WATERBURY FILING NO. 1 EL PASO COUNTY, CO CONSTRUCTION SET FEBRUARY 2023

EPC STORMWATER REVIEW COMMENTS IN ORANGE BOXES WITH BLACK TEXT

STAPLETON DRIVE  
STRIPING REMOVAL PLAN

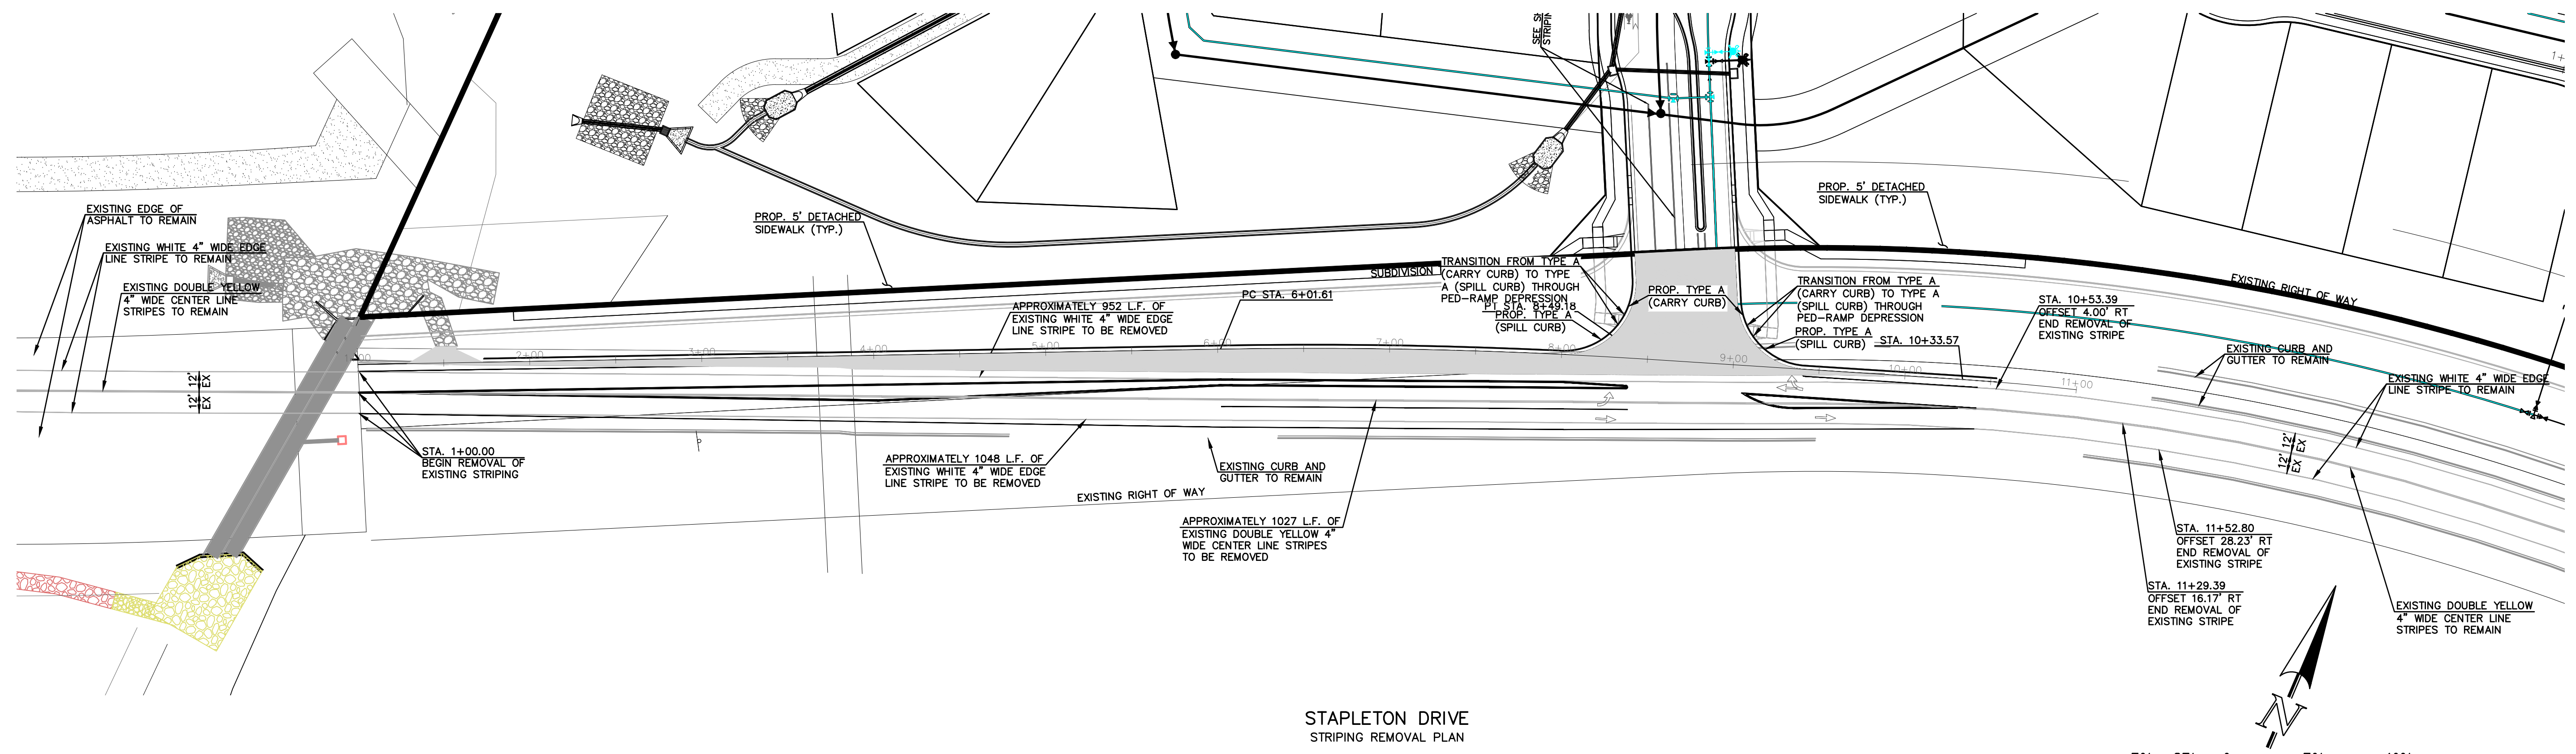
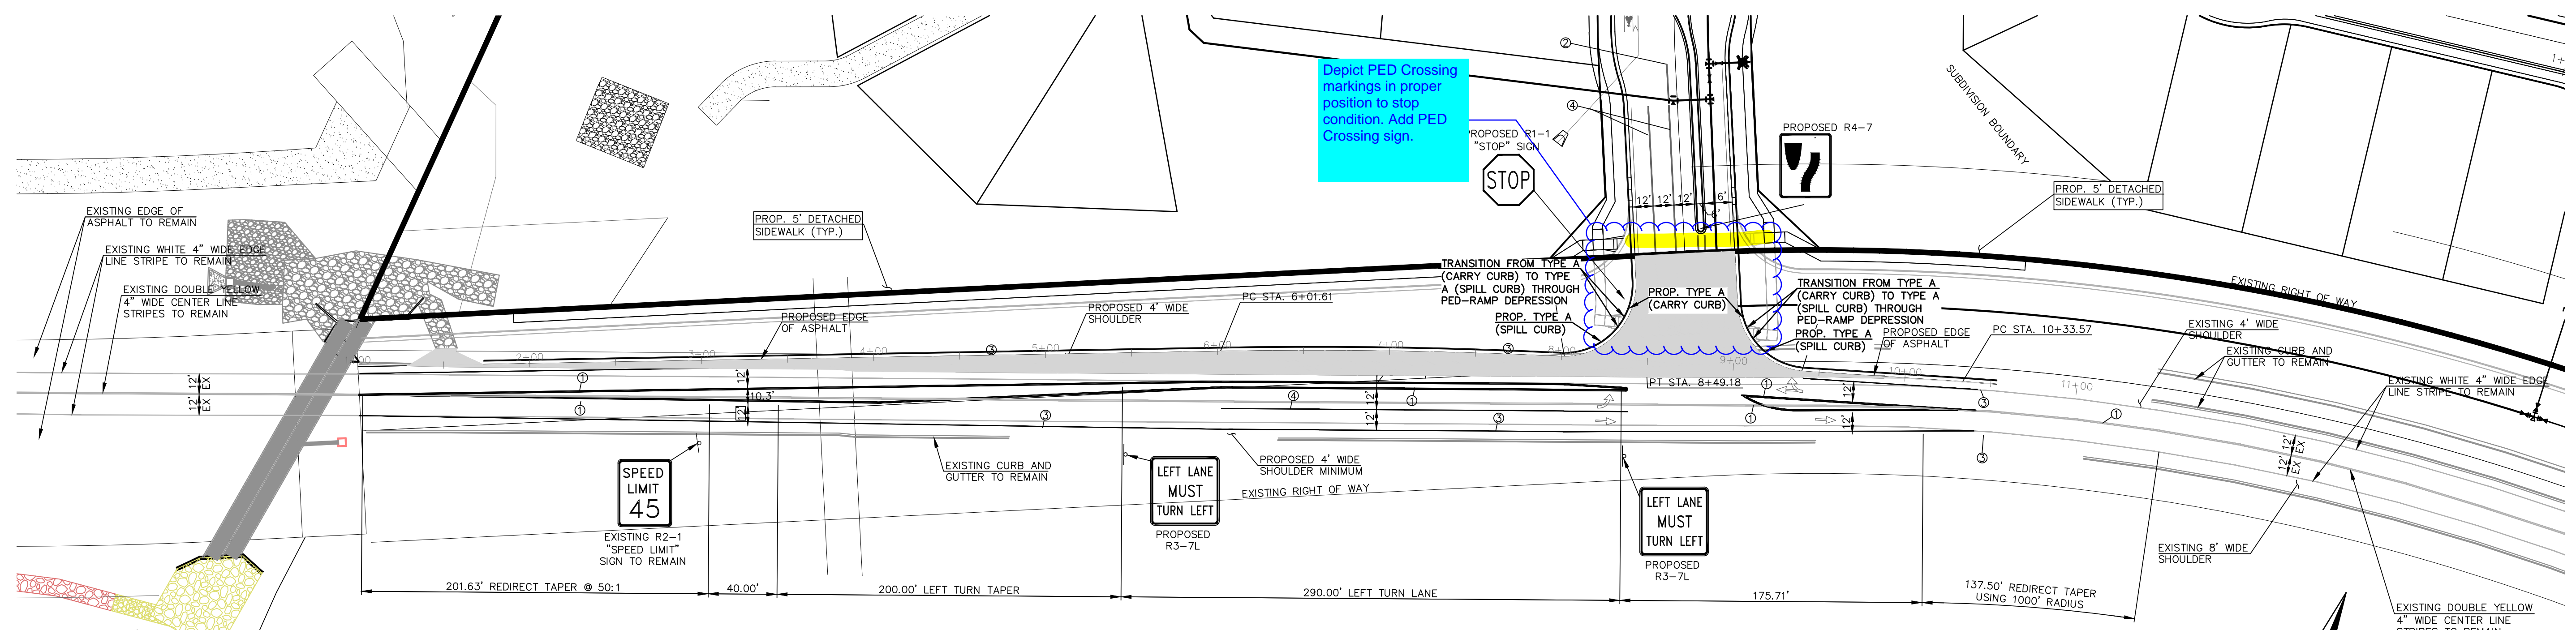
Depict PED Crossing markings in proper position to stop condition. Add PED Crossing sign.

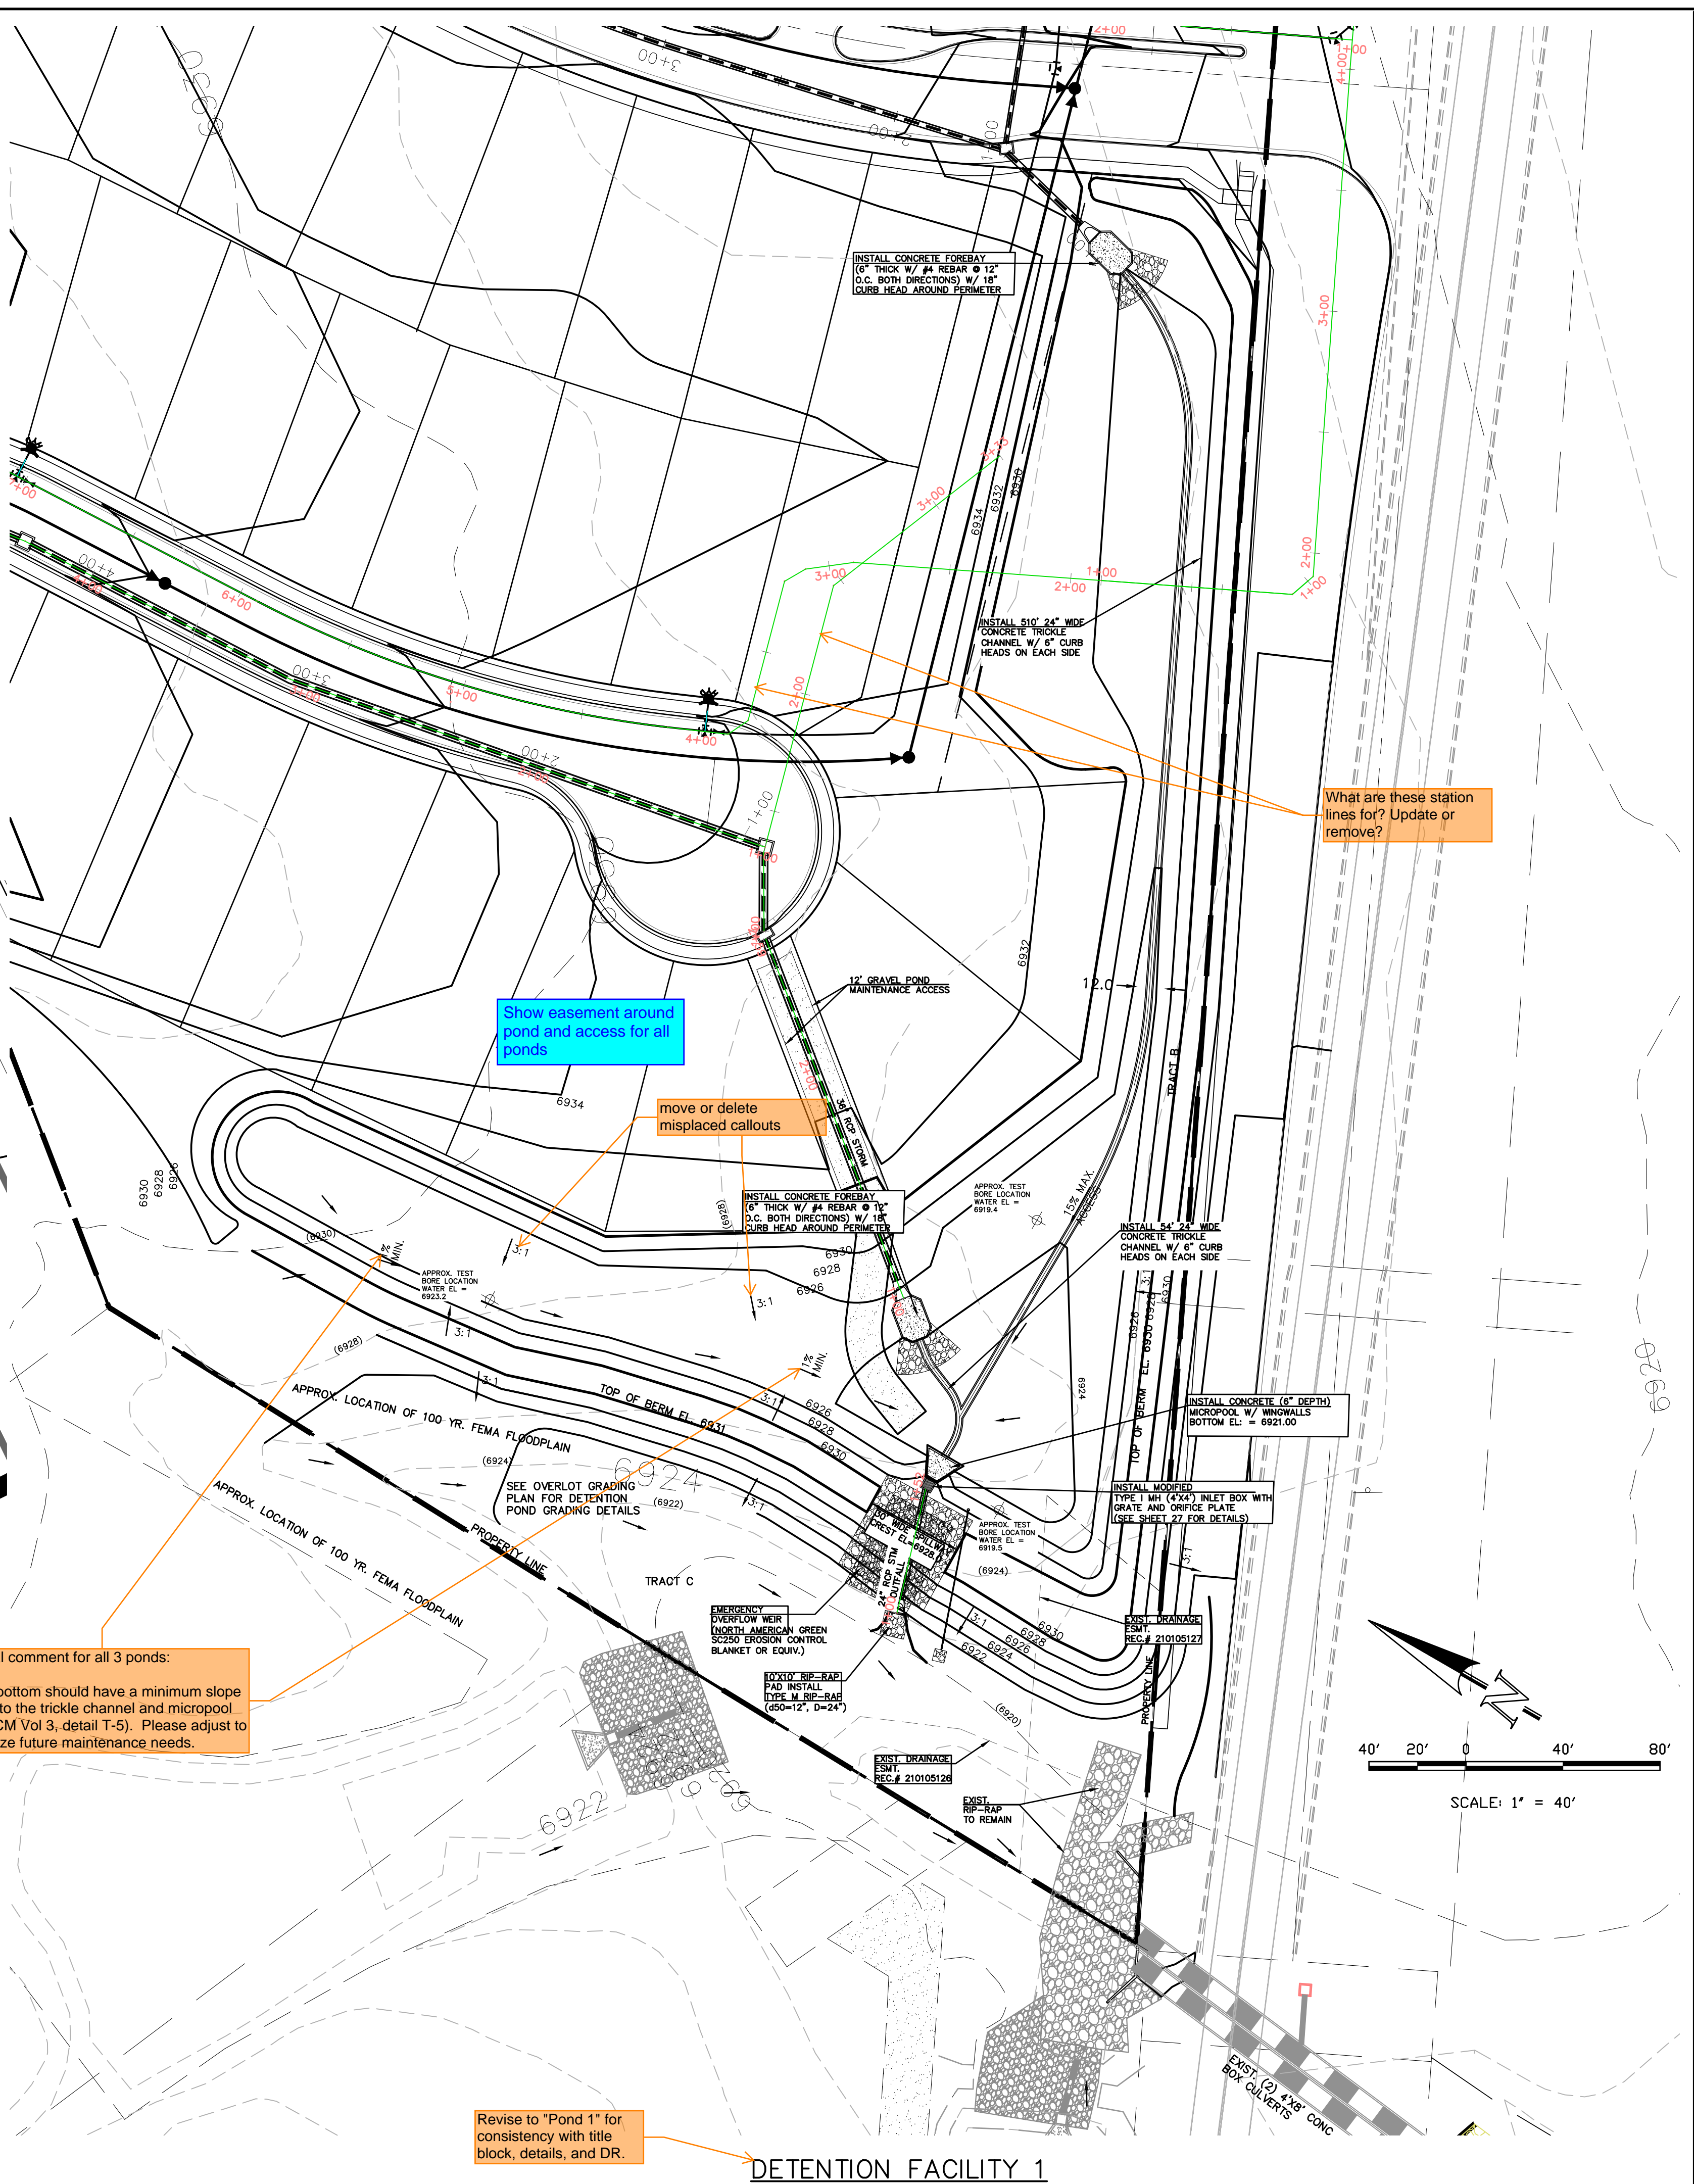
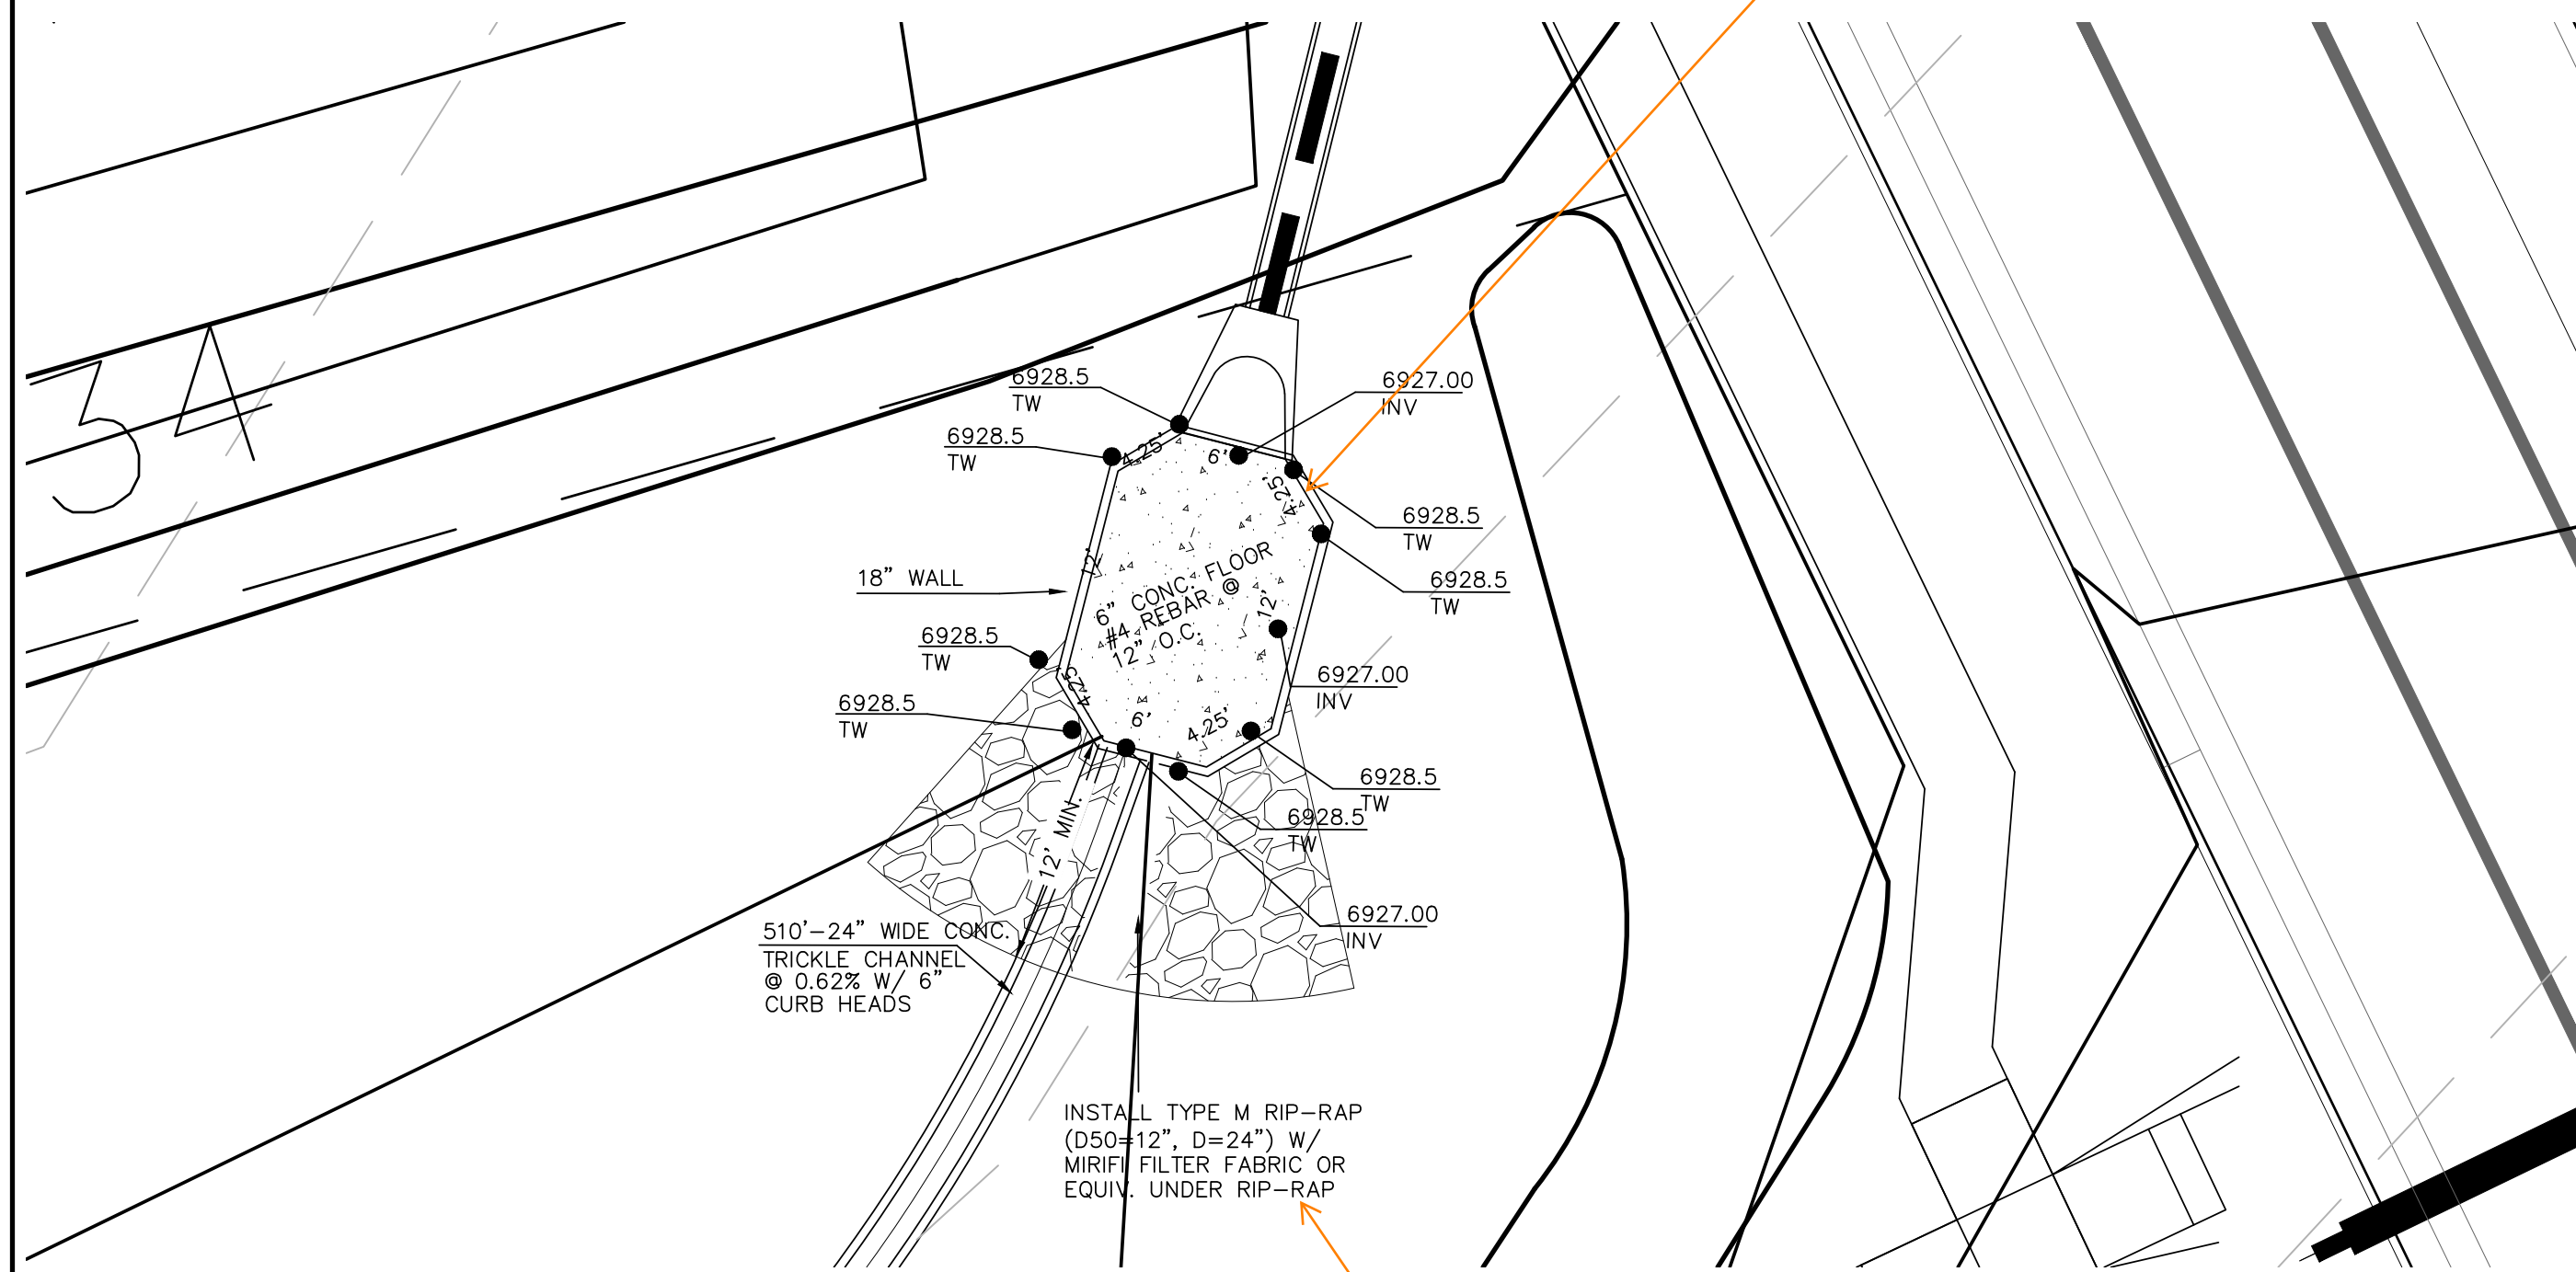
1) overlapping hatching is confusing as what the purpose of each is.  
 2) For detail on next page, spillway is not to have any riprap (just compacted earth), but this hatching is used elsewhere to represent riprap. Clarify to remove discrepancies.

Provide length dimensions for the spillway and thickness of riprap.

Provide dimensions for forebays. This should include the forebay notch width as well, or provide separate forebay detail. Typical for all ponds.

Provide the width as well.

Typical comment for all 3 ponds:  
 Pond bottom should have a minimum slope of 3% to the trickle channel and micropool (USDCM Vol 3, detail T-5). Please adjust to minimize future maintenance needs.

Revise to "Pond 1" for consistency with title block, details, and DR.

What are these station lines for? Update or remove?

Show easement around pond and access for all ponds

move or delete misplaced callouts

Typical comment for all 3 ponds:  
 Include callout for pet waste station(s) around the pond, with signage stating that pet waste must be picked up.
